**HMP Garth and HMP
Wymott, Moss Lane,
Ulnes Walton, Leyland**

ADDENDUM TRANSPORT PROOF OF EVIDENCE

APPLICATION 21/01028/OUTMAJ

VOLUME 2 - APPENDICES

Drawing Title
**PROPOSED MITIGATION WORKS
ULNES WALTON LANE / A581
PROPOSED MINI ROUNDABOUT**

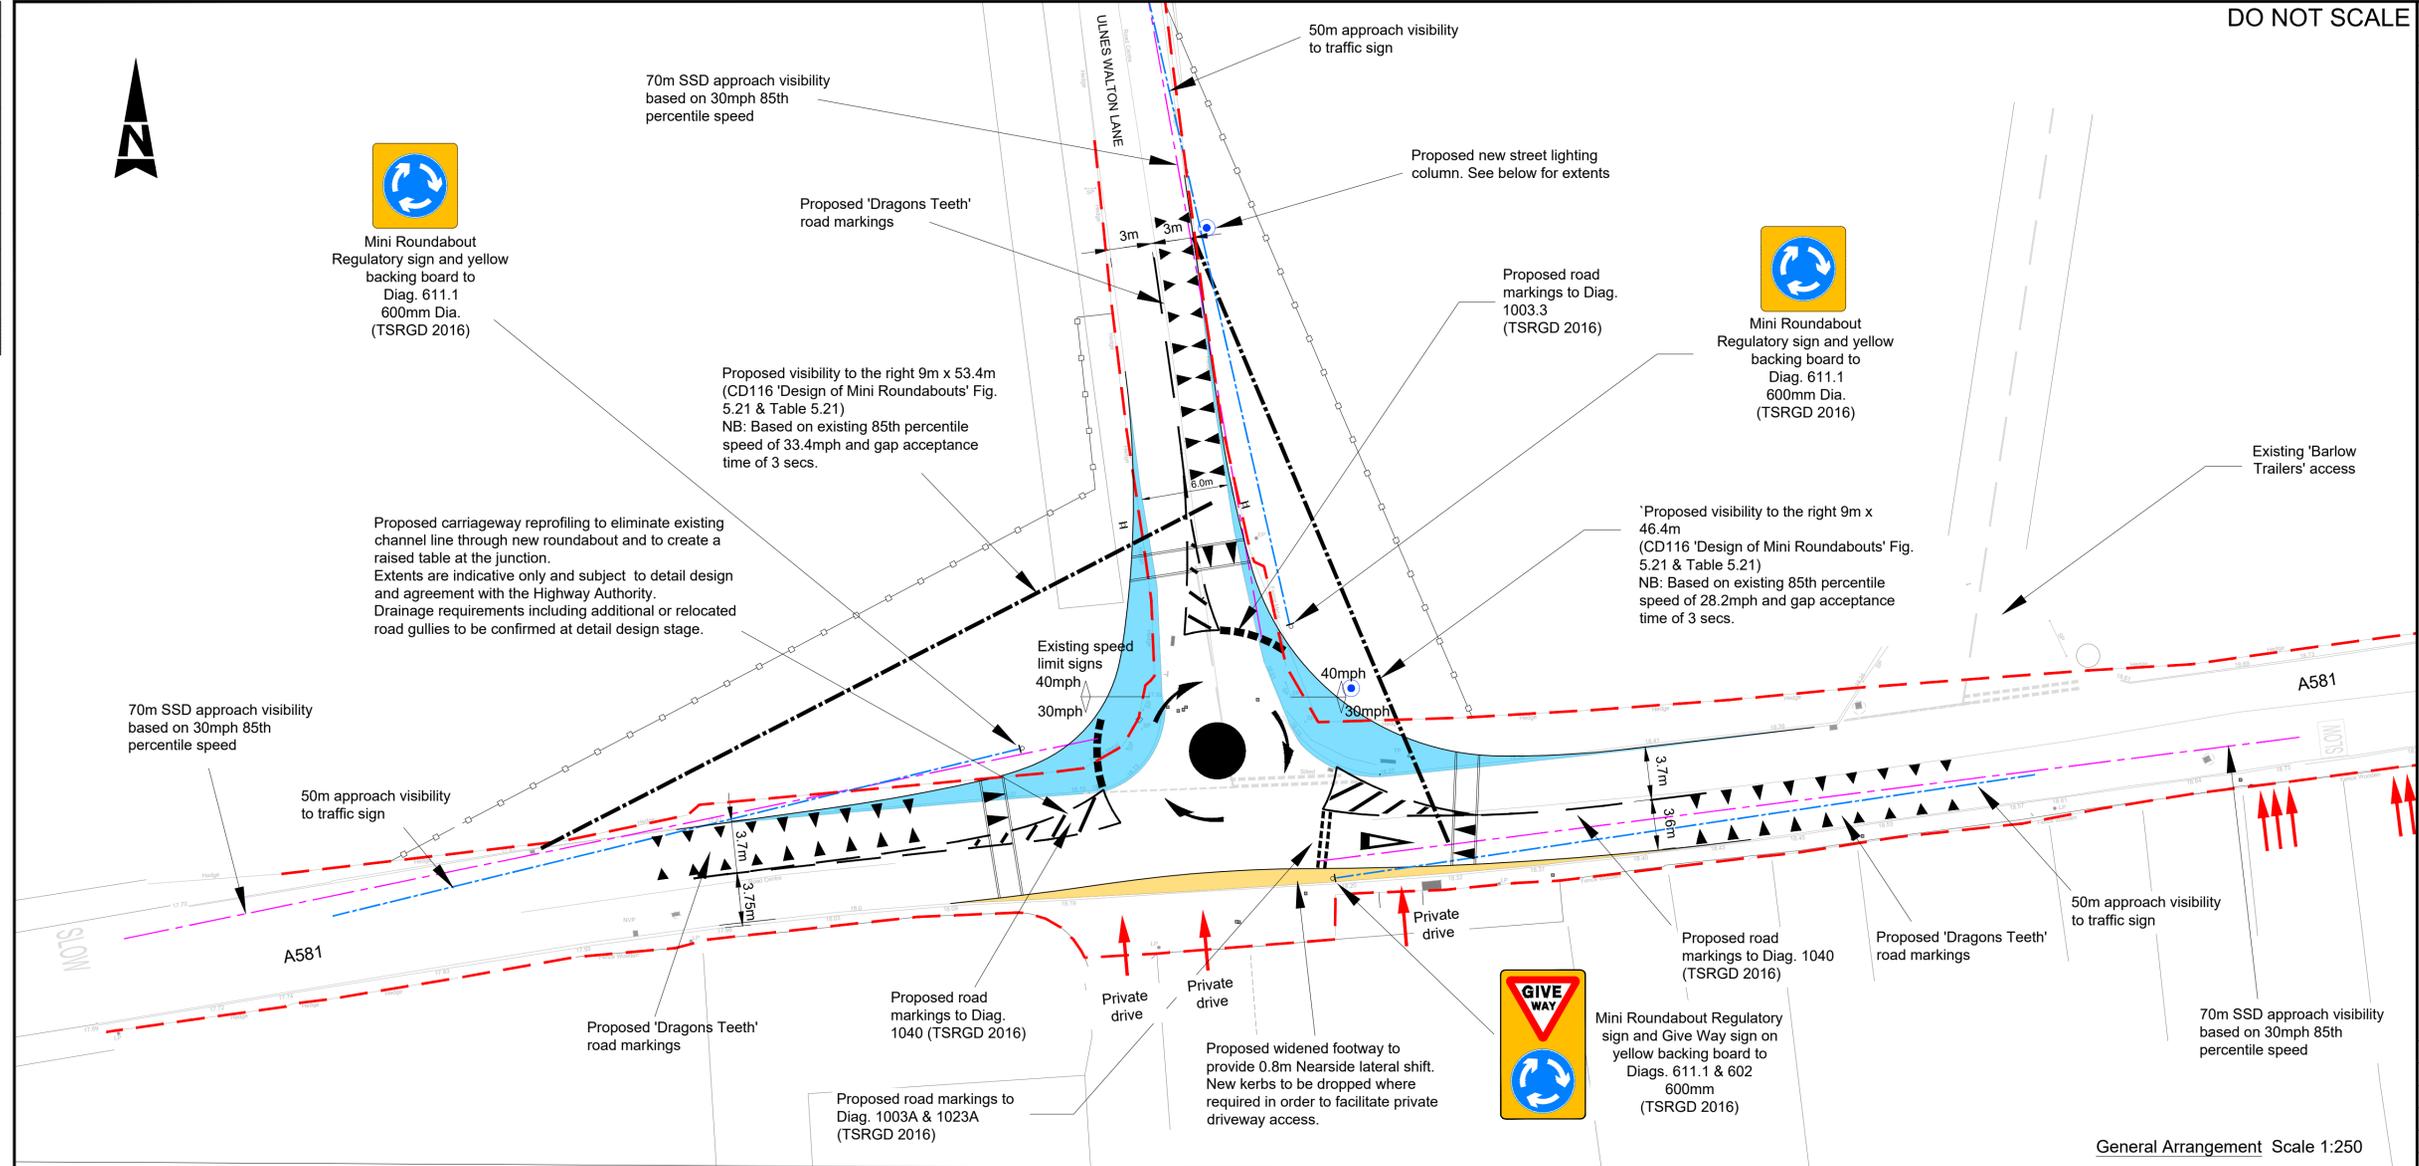
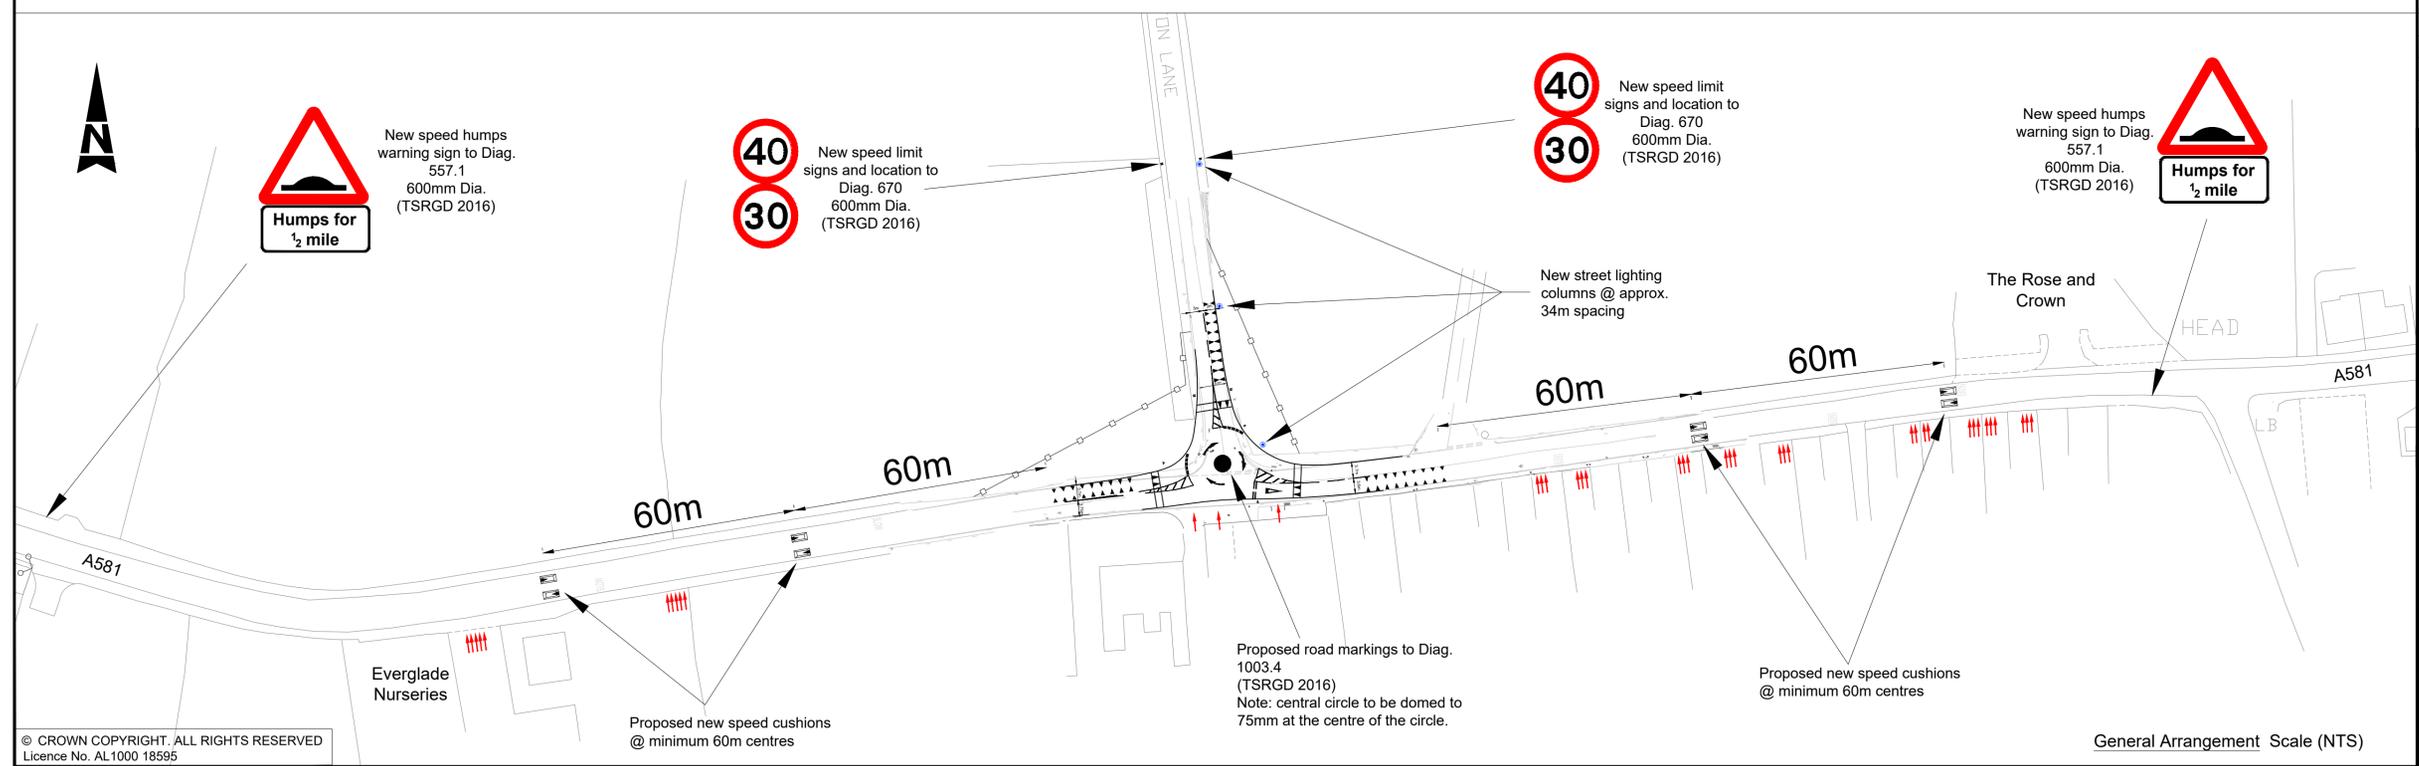
LCC welcome the additional land being brought into the scheme. LCC are pleased that the scheme is in line with the requirements set out within Manual for Streets (MfS) Table 7.1 and CD 116 ‘Design of Mini Roundabouts’ Figure 5.21 and Table 5.21, and that no visibility departures are now required for the scheme.

It is recommended that splitter islands are incorporated into the design within the proposed hatched areas. These would add definition to the road layout and junction form, especially if they can accommodate additional signing. However, consideration will need to be given to turning movements including from private driveways. Warning signs on each approach might also be appropriate, and/or direction signs could be converted to “map-type” to include the roundabout symbol.

If the cushions are more severe, the majority of drivers will slow - however many will also seek to reduce the slowing effect by adjusting their position on the road. This can result in traffic travelling along the road centre line to take a path in between the cushions, in order to experience a reduced vertical deflection. This can lead to head-on conflict with opposing traffic taking the corresponding line in the other direction. Again motorcyclists would be at particular risk of injury. The layout shown in the design appears to show the cushions in the centre of the existing running lanes, which can lead to this type of problem.
